# IMPORTANT PRODUCT UPDATE

Announcement Number: S02282501

## UPGRADED AND UPDATED 62TE High Pressure Tuneless™ Valve Body Reprogramming™ Kit

**OLD PART NUMBER:** 62TE-HP  
**NEW PART NUMBER:** 62TE-HP-A (UPGRADED)

#### Includes heavy-duty TCC solenoid retaining bracket and hardware

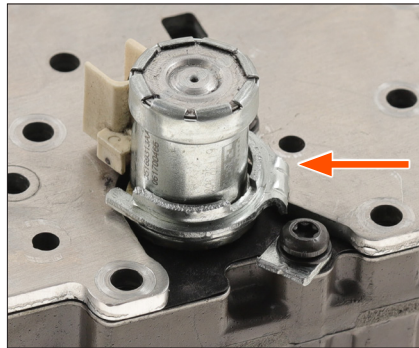
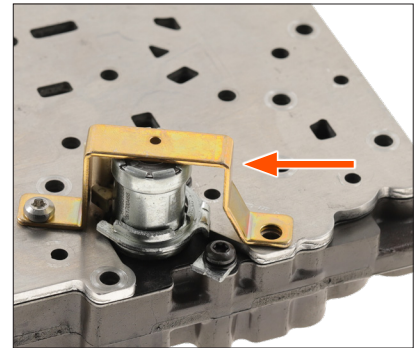
Reinforces the weak factory mounting tab (known for breaking in stock applications) causing various issues of delayed or no move forward, TCC slip, limp mode, vent leaking, low pressure codes and burnt UD clutches.

Factory bracket commonly broken

TransGo HD retaining bracket

#### Improved 2-piece drill guide for greater accuracy when drilling by hand

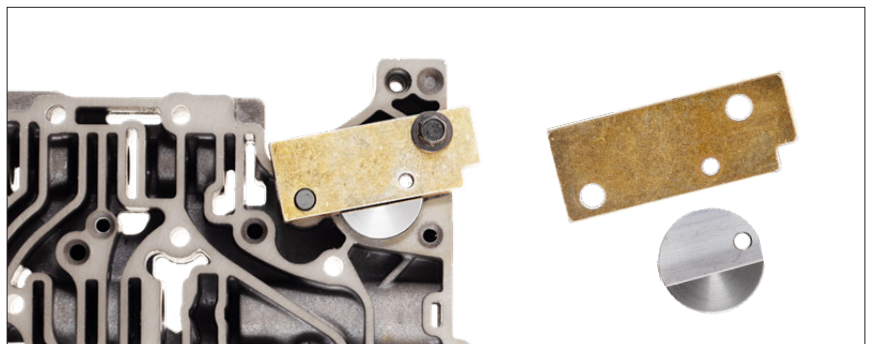
The new jig with full length piloting guide helps to ensure accurate vertical drilling, especially when using hand drills.
